BURLINGTON & SIERRA MASTER PLAN **SUBDIVISION**

APPLICATION NUMBER 5 DATE October 15, 2015

DETAIL SITE PLAN

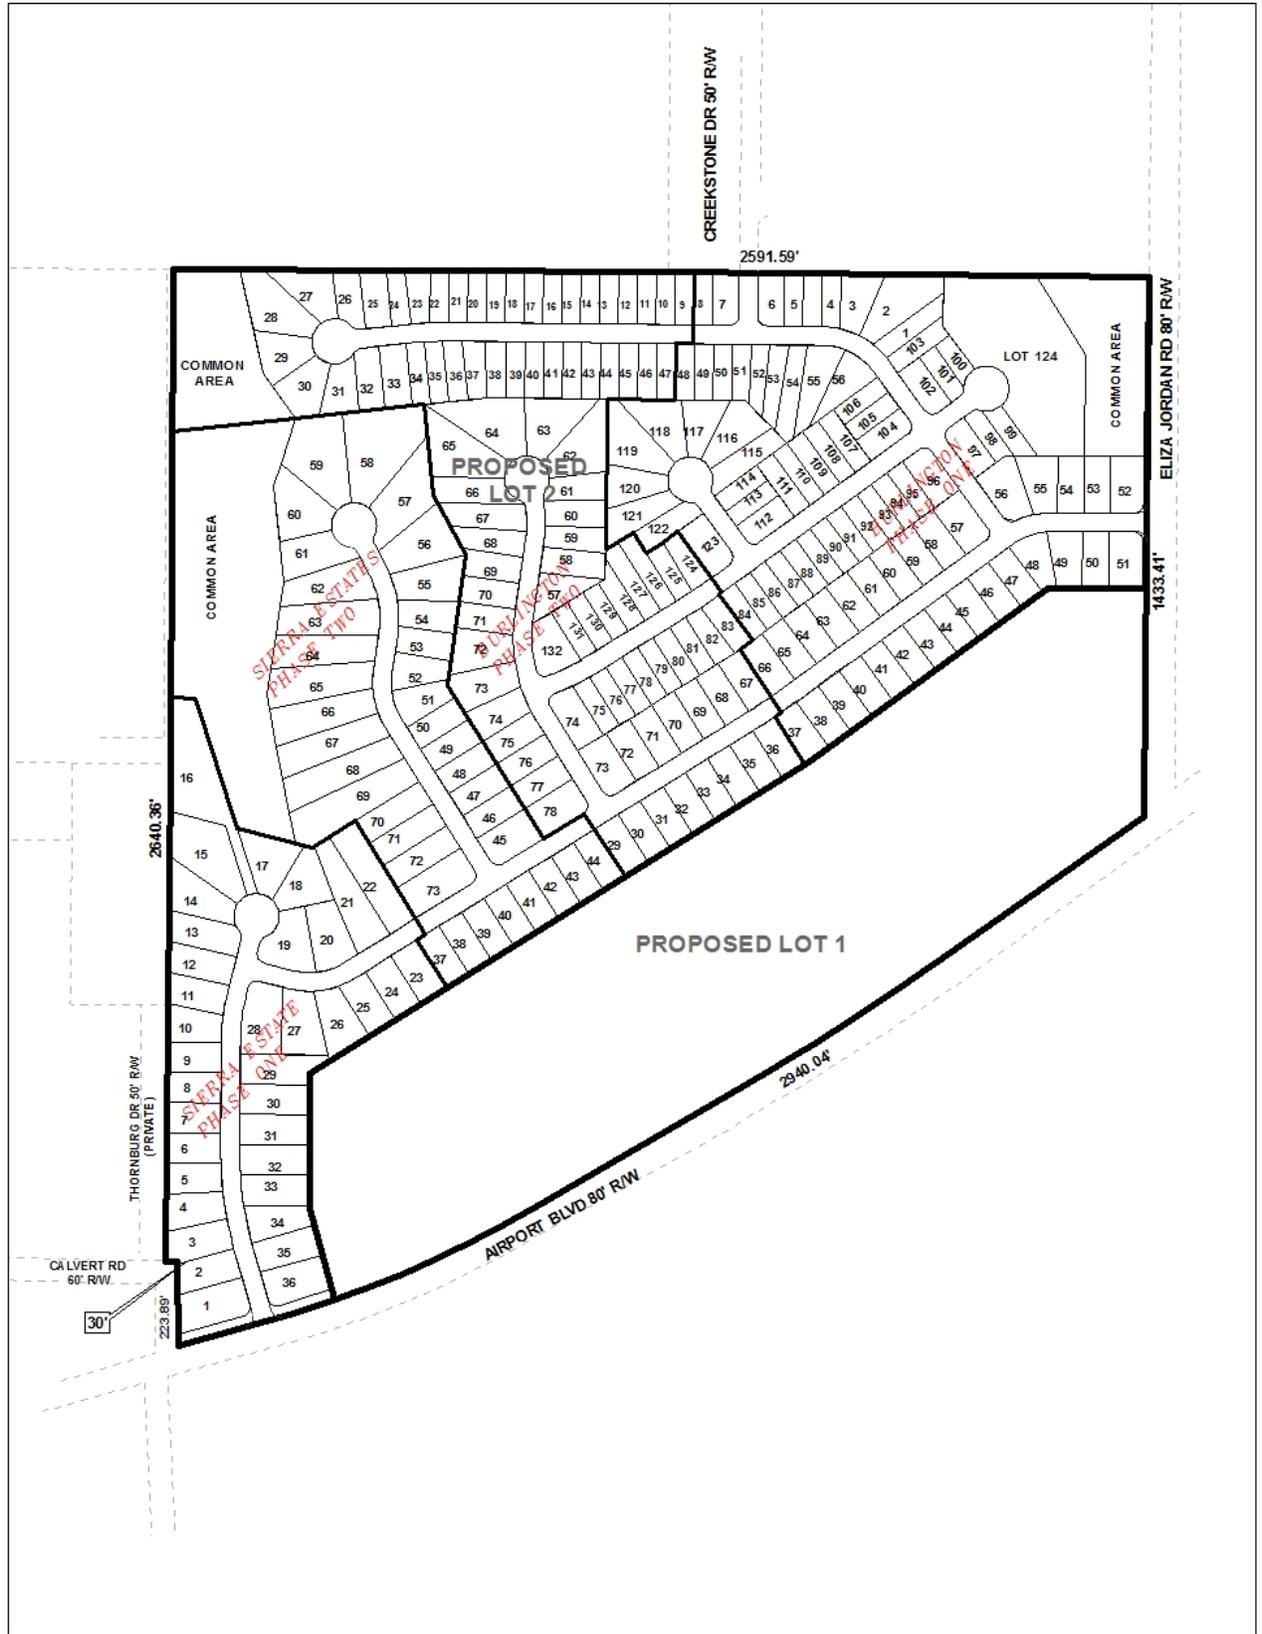
The site fronts Airport Boulevard and Eliza Jordan Road South which are both components of the Major Road Plan with planned 100' rights-of-way. As the current right-of-way width along both frontages is 80', dedication sufficient to provide 50' from the centerline of each would be required. The 25' minimum building setback line is only indicated along the existing frontages of Airport Boulevard and Eliza Jordan Road. This should be revised on the Final Plat so as to be measured from any required street frontage dedication. None of the internal lots have an indicated minimum building setback line; therefore, the plat should be revised to indicate the 25' minimum building setback line along all street frontages.

Access management is a concern along Airport Boulevard and Eliza Jordan Road South; therefore, a note should be required on the Final Plat, if approved, stating that Lots 1 and 36, Sierra Estates Phase One, are denied access to Airport Boulevard, and Lots 51 and 52, Burlington Phase One, are denied access to Eliza Jordan Road South. The plat indicates three common areas without any designated access points. Therefore, dedicated access within the Subdivision should be provided to all common areas. Access should be denied to the common

area along Eliza Jordan Road South from that road. Access should be denied to Thornburg Drive (private road) and Calvert Road North, both along the West side of the site. All lots and common areas should be limited to one curb cut each, with the size, location and design to be approved by Mobile County Engineering.

No lot areas are indicated on the preliminary plat. The plat should be revised to indicate the lot sizes in both square feet and acres. Lots 1 and 36, Sierra Estates Phase One, and Lots 51 and 52, Burlington Phase One, should be revised to indicate lot sizes after any required street frontage dedication.

Section V.D.2. of the Subdivision Regulations establishes minimum lot dimensions and areas. The plat scales to indicate that many of the proposed lots are of substandard width (less than 60' wide at the building setback line) and/or of substandard size (less than 7,200 square feet). Many of the lots are only 50' wide at the setback line and contain as little as 6,900 square feet. And Section V.D.3. states that the depth of lots shall not be more than 3.5 times the width of the lot at the building setback line. Several of the lots exceed the allowable ratio. As there was no justification submitted with the application to allow substandard lot dimensions and areas as an innovative subdivision, and as there are no existing innovative subdivisions within the area approved by the Commission, the subject application cannot be considered for approval as presented.

No drainage easements associated with the common areas, or any easements for that matter, are indicated on the plat. If any easements are proposed, they should be indicated on the preliminary plat.

The site has closed-end streets that exceed 600 feet. Thus, a waiver of Section V.B.6 of the Subdivision Regulations would be required. The plat indicates a compliant turnaround right-of-way diameter of 120 feet and this should be retained on the Final Plat, if approved. Some of the streets which contain more than 30 lots have only one access point. Appendix D of the IFC, requires two points of access for single-family subdivisions with 30 or more lots. Therefore, the applicant should either obtain written approval from the State Fire Marshall to allow one point of access for portions of the Subdivision containing more than 30 lots, or the plat should be revised to provide a second access point for those portions.

The site has property lines at an intersection corner. Section V.D.6. of the Subdivision Regulations requires that "*property lines at street intersection corners shall be arcs having radii of at least 10 feet or shall be chords of such arcs.*" The curb radii is depicted on the preliminary plat, and if approved should be depicted on the Final Plat as well.

RECOMMENDATION This application is recommended for denial due to the following reasons:

- 1) many of the lot dimensions and lot areas are not compliant with Section V.D.2. of the Subdivision Regulations;
- 2) some of the lots are not compliant with Section V.D.3. of the Subdivision Regulations with respect to the lot width-to-depth ratio;
- 3) no justification has been provided to allow this as an innovative subdivision;
- 4) some portions of the Subdivision contain 30 or more lots on streets with only one access point, contrary to Appendix D of the 2012 IFC; and
- 5) depending upon the resolution of the disputed Western boundary line and easement for ingress and egress to Parcels R022709290000011 and R022709290000011.001, access points to those land-locked parcels may be necessary.
